# WEST MIDLANDS INTERCHANGE

## Transport Technical Note 46 – A449 / A5 Link Road Signalised Crossing

| <b>Subject</b>      | A449 / A5 Link Road Signalised Crossing (Final) |                       |                 |

**OUR REF. NO. ITS/496/2019 REV G**

| Drawing No.<br><b>WSP-70001979-GA-103</b>   |                         |

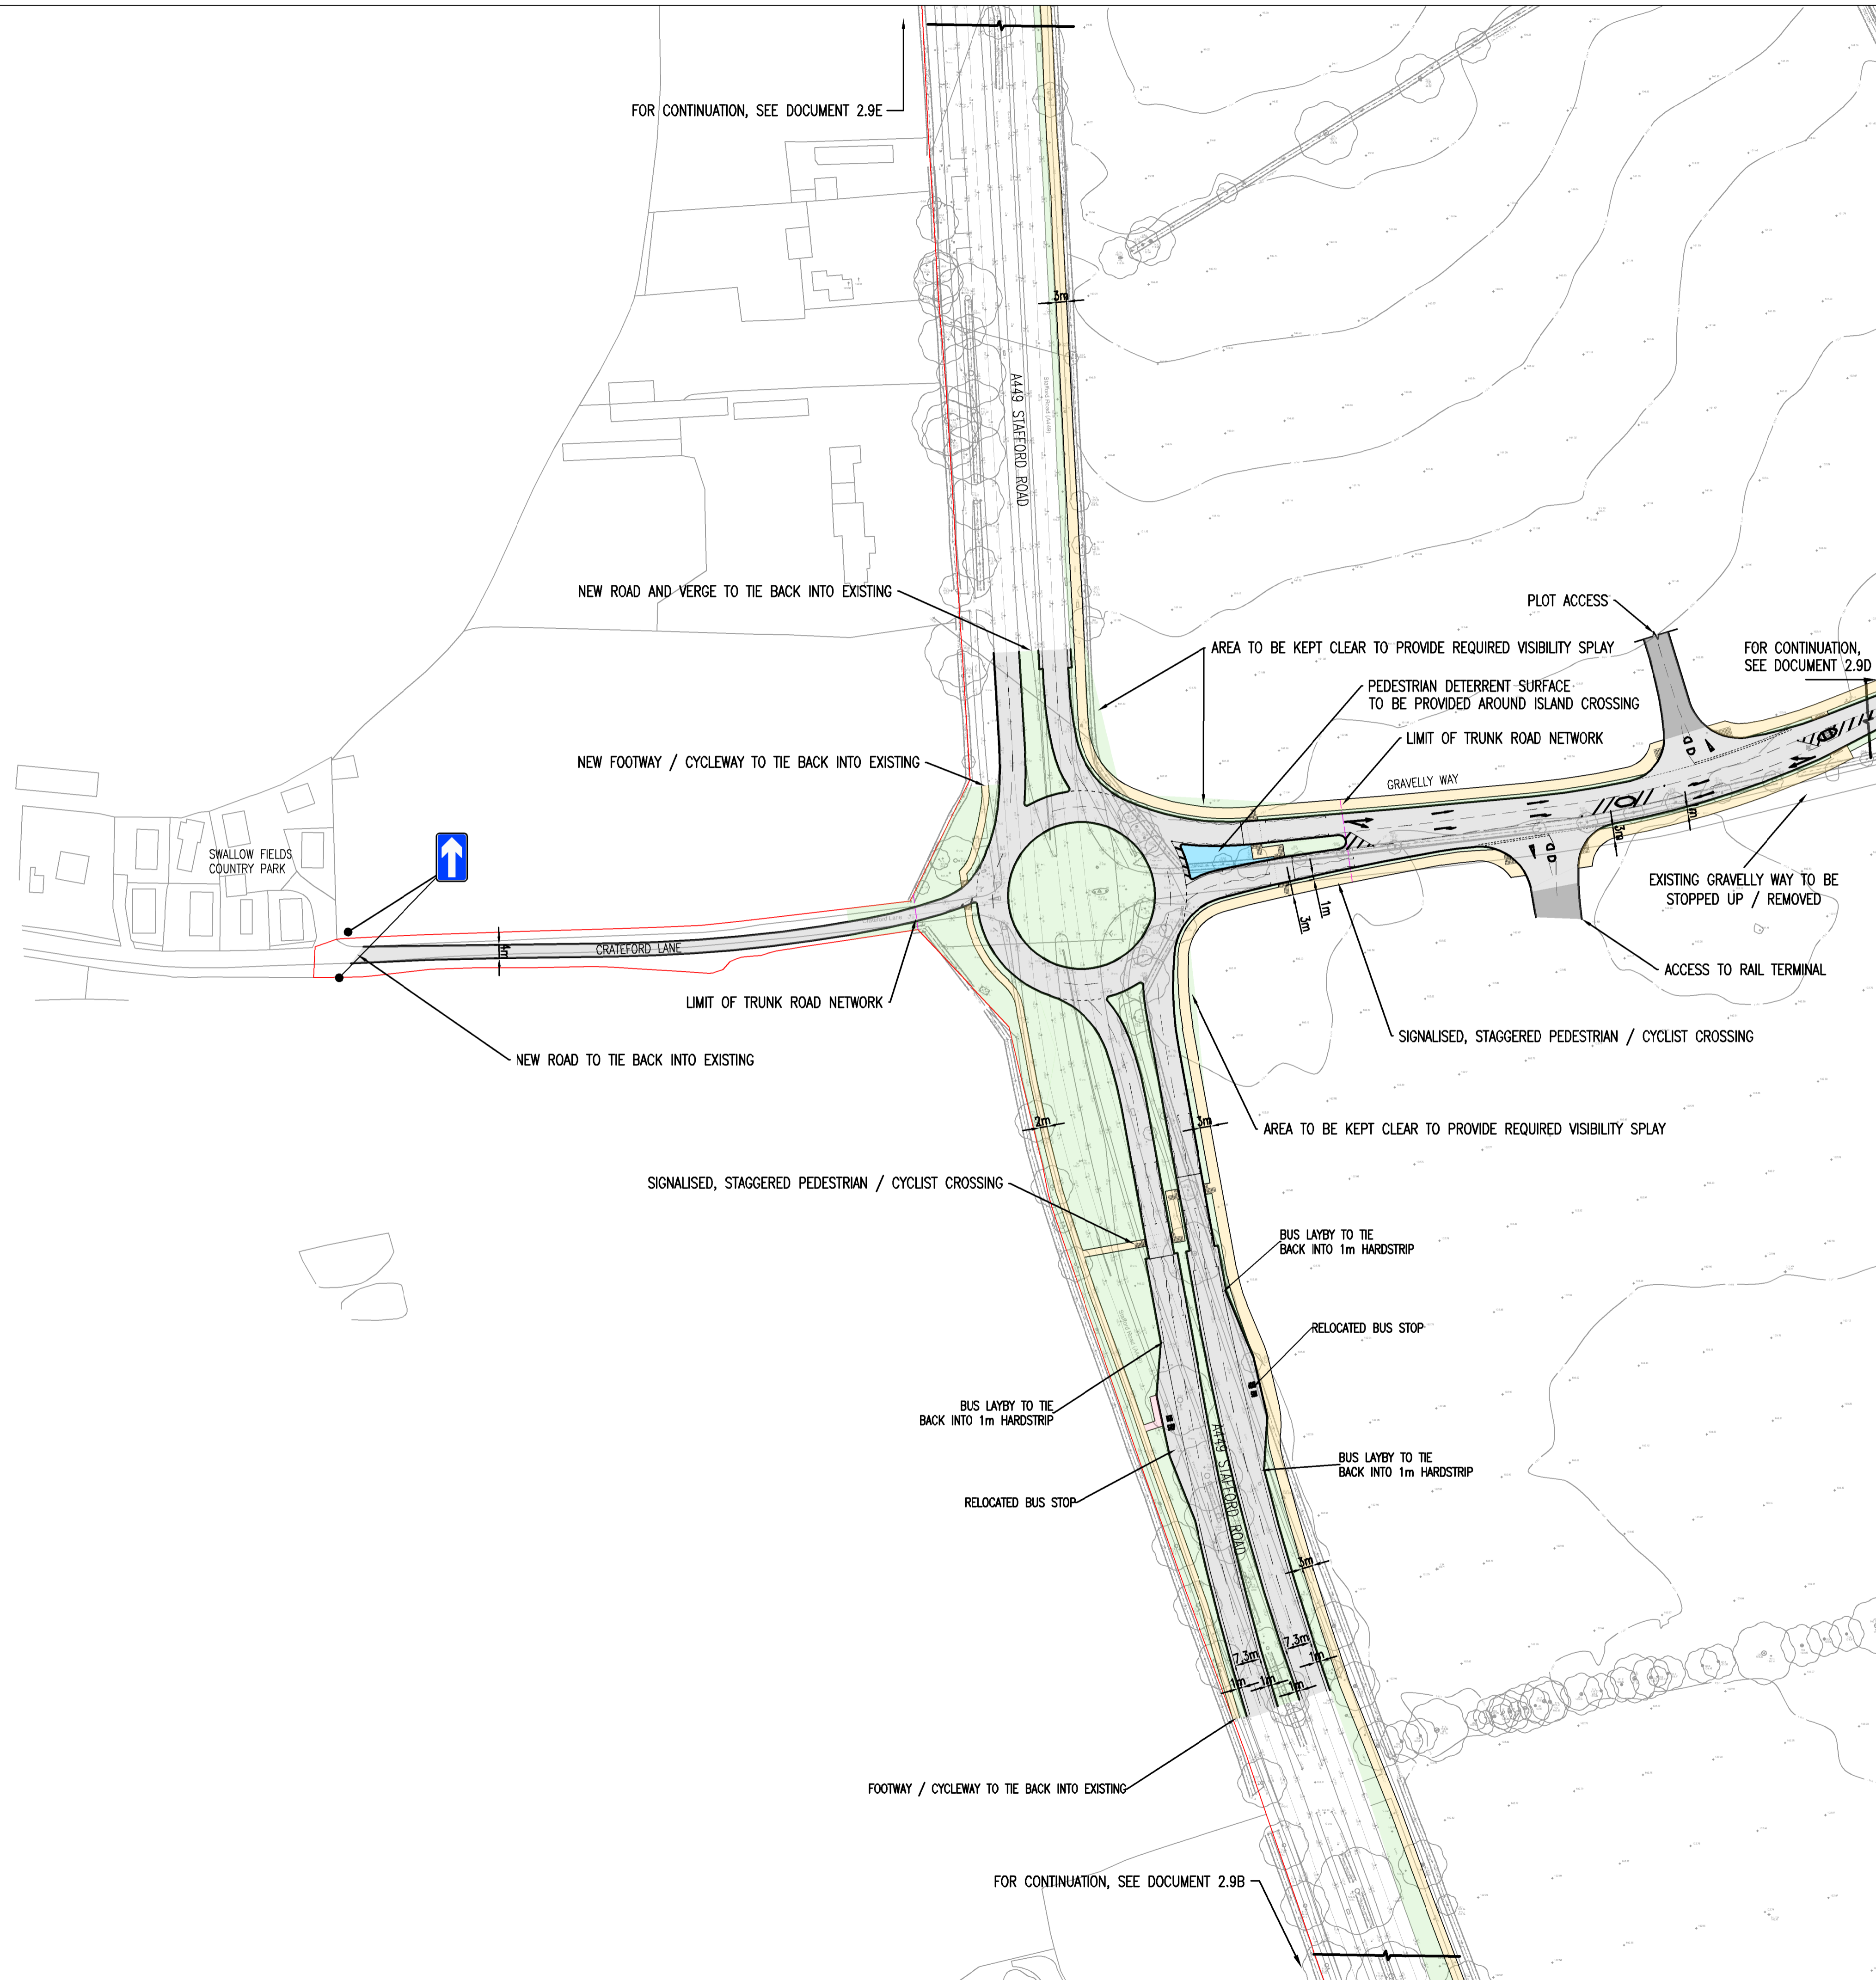
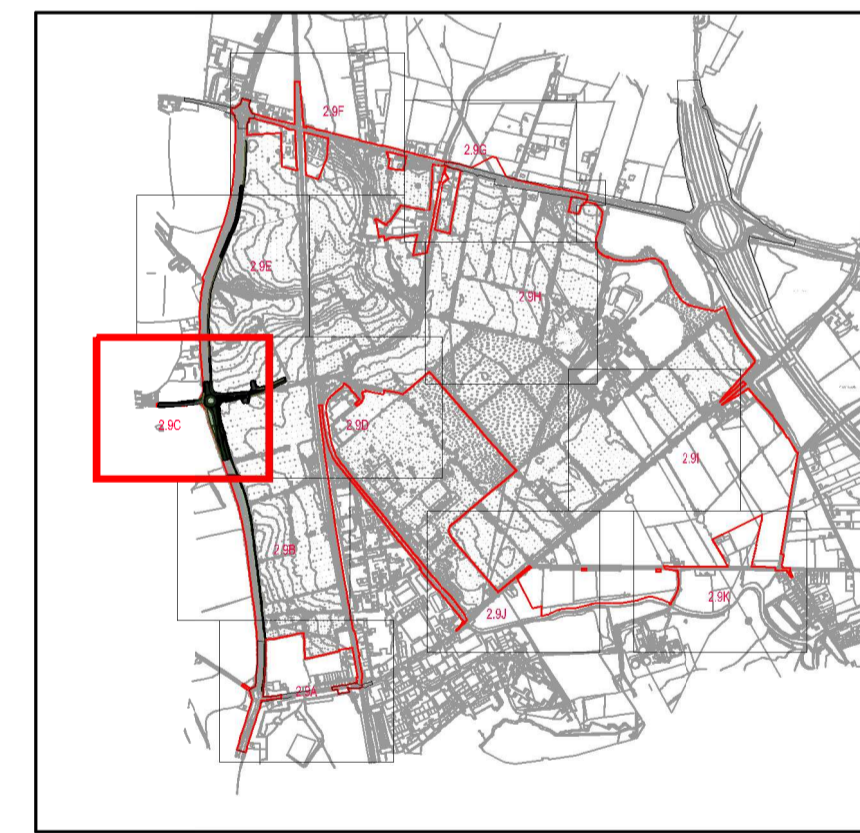
- 1.6 The further RSA1 had considered the proposal of the Applicant to relocate the signal controlled crossing so that it sits 20m to the east of the exit from the A449 roundabout. The reason for this was to provide the crossing on the desire line for Non Motorised Users (NMUs), but not trigger a departure from design standard which would have been the case if it were located further to the west. Previous proposals for the crossing were considered to be provided in a location that did not reflect anticipated desire lines and would give rise to NMU’s attempting to cross the link road in locations where crossings were not present. This issue had been raised by a previous Safety Audit, dated June 2019 (Rev F) and had been responded to by the Applicant by way of drawing 70001979-GA-103 Rev I.

- 1.7 The Safety Audit Rev G has confirmed on page 19 that the location of the crossing is now shown in a location that will not give rise to NMU’s choosing to cross at locations where there is no crossing facility. Therefore the risk of an NMU being struck by a vehicle whilst attempting to cross in an unsuitable location has been satisfactorily removed.

- MAY 2019**
- PEDESTRIAN CROSSING ON THE A449 SIGNALISED AND RELOCATED FURTHER SOUTH OF THE ROUNDABOUT, IN RESPONSE TO COMMENTS FROM HIGHWAYS ENGLAND IN THE RSA.

- PEDESTRIAN CROSSING ON GRAVELLY WAY MOVED EAST, STAGGERED AND SIGNALISED IN RESPONSE TO HIGHWAYS ENGLAND COMMENTS IN THE RSA AND AS A RESULT THE ACCESS TO THE RAIL TERMINAL HAS BEEN MOVED EAST. THE TOTAL WIDTH OF THE GRAVELLY WAY ARM HAS BEEN INCREASED TO PROVIDE SUFFICIENT WIDTH FOR THE CROSSING AND VEHICLE MOVEMENTS.

- THE EXTENT OF THE TRUNK ROAD NETWORK HAS BEEN RELOCATED EAST, TO THE BACK OF THE REDESIGNED SPLITTER ISLAND.
  - ADDITIONAL VERGE ON THE EASTERN SIDE OF THE A449 HAS BEEN ALLOCATED TO ENSURE VISIBILITY TO THE PEDESTRIAN CROSSINGS IS PROTECTED.

- JULY 2019**
- AMENDMENT TO CROSSING OF LINK ROAD IN RESPONSE TO COMMENTS FROM HIGHWAYS ENGLAND AND RSA.
  - CROSSING AREA AS CENTRAL ISLAND OF GRAVELLY WAY REVISED.

- PEDESTRIAN DETERRENT SURFACING ADDED TO CENTRAL ISLAND ON GRAVELLY WAY.
- AUGUST 2019**
- AMENDMENT TO CROSSING ON LINK ROAD IN RESPONSE TO COMMENTS FROM RSA AND GG104 SAFETY RISK ASSESSMENT.
